Town of Dover Community Center

VE Items -
Bid Changes for Re-bidding
Documents

Feb. 01, 2023

Window Frame Modifications

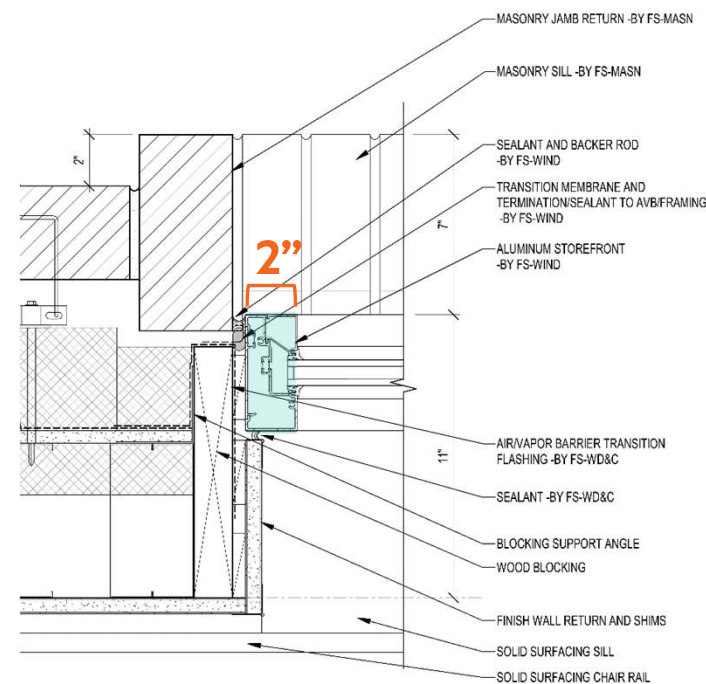
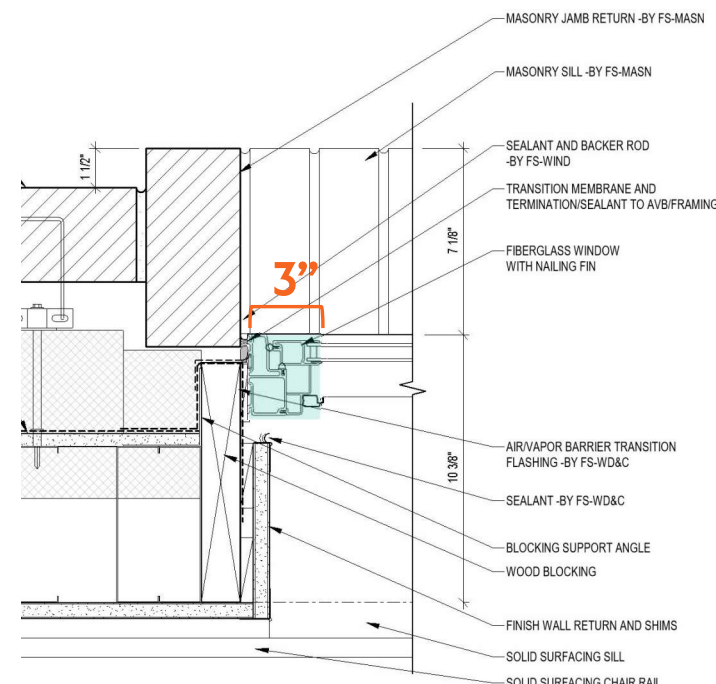
Bid Docs Change; Aluminum to Fiberglass Windows

2022 Bid Docs:

➤ All *new* aluminum frame windows at all punched openings (new and existing)

Value (with change):

➤ High Value; w/ Fiberglass windows highly energy efficient, eliminates metal windows as a Filed Sub Bid

Savings Anticipated:

➤ \$40,000 +/-

➤ Currently; Changes are being made to Bid Documents to incorporate this change for a June 2023 STM

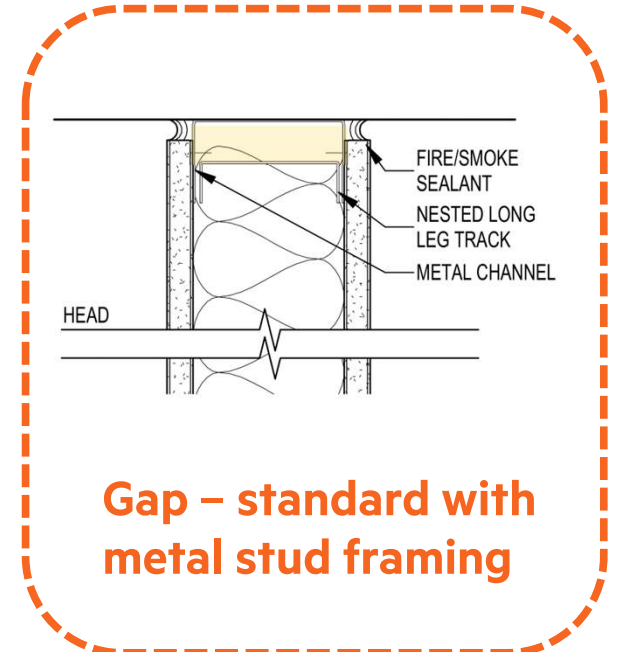
- Would require custom slip track or atypical detailing to “gap the wall” at the top (as to not become a bearing wall condition). Open to additional risk with atypical conditions.
- Height is limiting for wood (seasonal movement)
- Might mean two framing crews on site, limiting bidding pool
- Structural, Specification Writer and Estimator all recommend not pursuing
